SERVICE NOTICE

NUMBER: SN-021
REVISION: A
DATE: 12/07/2009

SUBJECT: GARMIN SERVICE BULLETIN 0823, REVISION C

SUBJECT: GDU 104X CRS/BARO Knob Interference

Figure 1

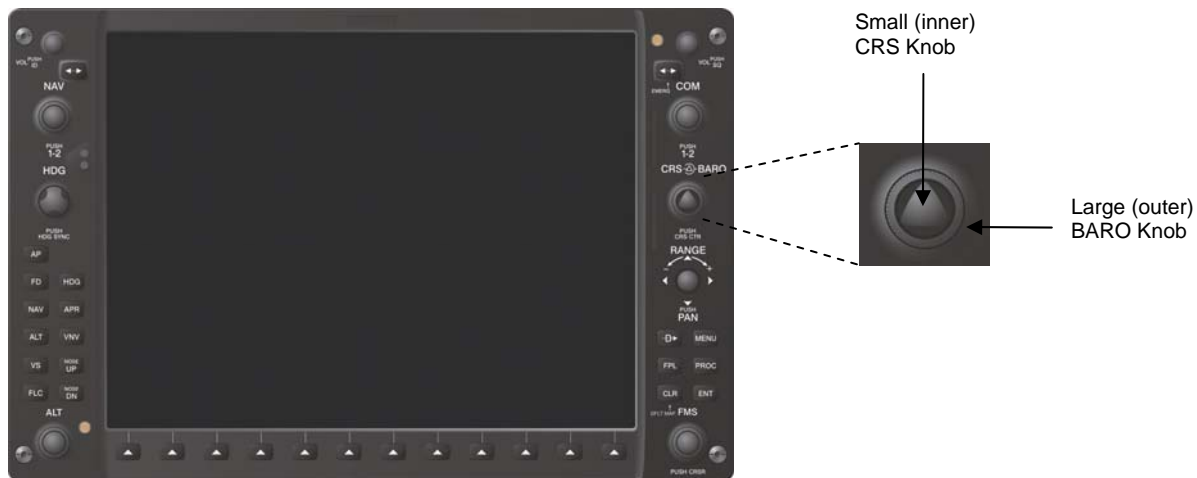
Garmin has identified an issue, whereby the large (outer) BARO knob and the small (inner) CRS knob may interfere with each other.

1. Apply power to the G1000/G900X/G950.
2. Press the CDI softkey on the Primary Flight Display(s) (PFD) to enter VOR mode on the HSI.
3. Rotate the large (outer) BARO knob (refer to Figure 1) a minimum of three complete revolutions in each direction while monitoring the Horizontal Situation Indicator/Digital Course Indicator (refer to Figure 3) on the PFD. If a change in the Horizontal Situation Indicator/Digital Course Indicator is produced while turning the BARO knob proceed to the Modification Instructions.

4. Rotate the small (inner) CRS knob (refer to Figure 1) a minimum of three complete revolutions in each direction while monitoring the Barometric Altimeter Setting (refer to Figure 3) on the PFD. If a change in the Barometric Altimeter Setting is produced while turning the CRS knob proceed to the Modification Instructions.
5. Repeat Steps 3 and 4 for each affected GDU.

If CRS/BARO Knob interference is confirmed, perform the steps below to replace the CRS/BARO Knob. New knobs can be obtained through a Garmin Service Center or Aircraft OEM under Garmin part number K00-00446-00.

1. Grasp the small (inner) CRS knob and firmly pull the knob off the shaft.
2. Discard knob.
3. Grasp the large (outer) BARO knob and firmly pull the knob off the shaft.
4. Discard knob.

Figure 4

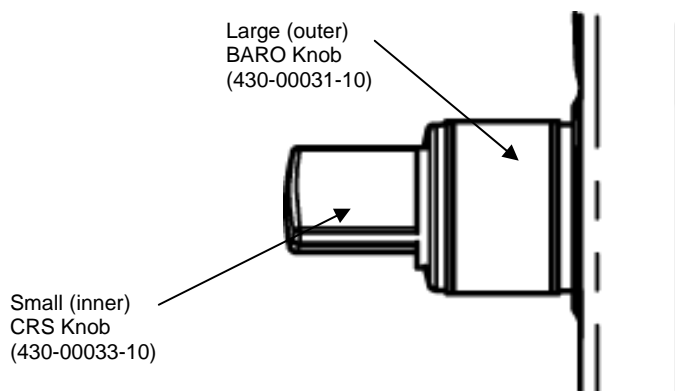
5. Grasp the large (outer) BARO knob (insuring proper orientation) and place it over the shaft.
6. Align the flat side of the knob insert with the flat side of the shaft.
7. Press down firmly to ensure knob is completely seated, refer to Figure 4.
8. Grasp the small (inner) CRS knob (insuring proper orientation) and place it over the shaft.
9. Align the flat side of the knob insert with the flat side of the shaft.
10. Press down firmly to ensure knob is completely seated, refer to Figure 4.
11. Perform the CRS/BARO Knob Interference Test (contained in the TESTING PROCEDURE section) again to confirm there is no interference.
12. Accomplish aircraft logbook entry to return aircraft to service in compliance with this service bulletin.
